## ENVIRONMENTAL REVIEW COMMITTEE REPORT

| <b>Project Name:</b>         | Brennan 3405 Dock Construction  |   |     |
| <b>File Number:</b>          | LUA10-011, ECF, SM, SMC   |   |     |

# EXHIBIT 5

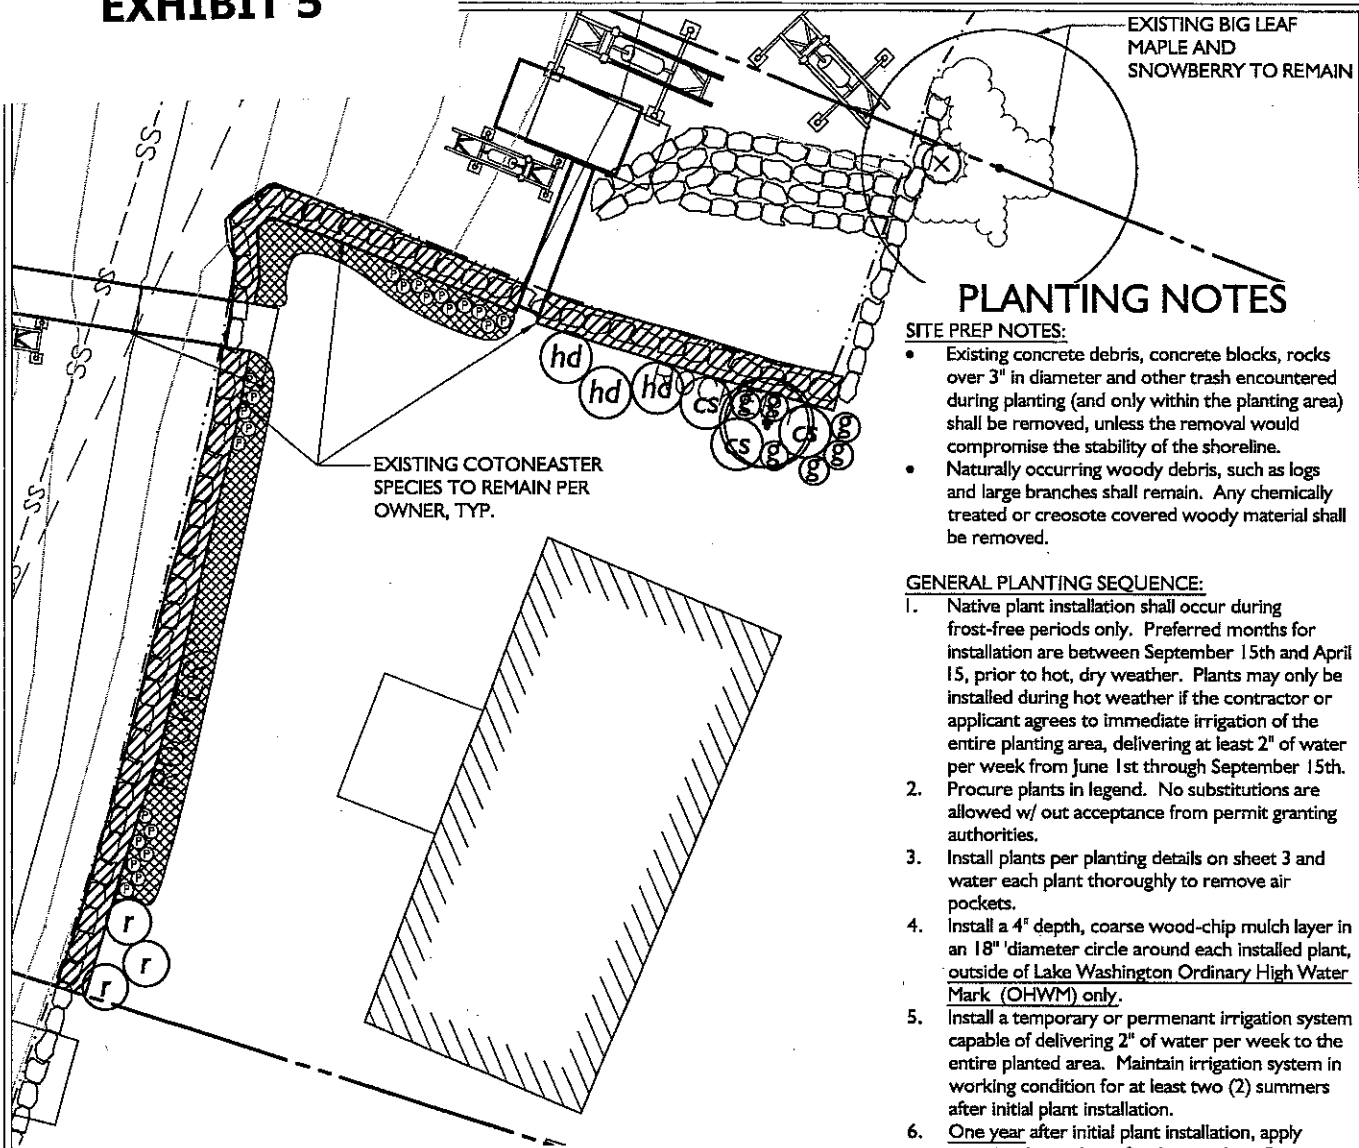
2. The planting plan should be modified to include more native willows, particularly along the bulkhead length that is oriented N/S. We recommend that the proposed red flowing currant be replaced with 1 or 2 native willows and that additional willows should be added elsewhere along the N/S bulkhead to increase overhanging vegetation to benefit juvenile salmon

In its comments on the proposed project, the Muckleshoot Indian Tribe has recommended the planting of native willows along the existing bulkhead to increase overhanging vegetation to benefit juvenile salmon. The applicant has responded that there is only a small area available for plantings and that previous plantings currently provide overhanging vegetation while still providing views of Lake Washington for the residents of the property.
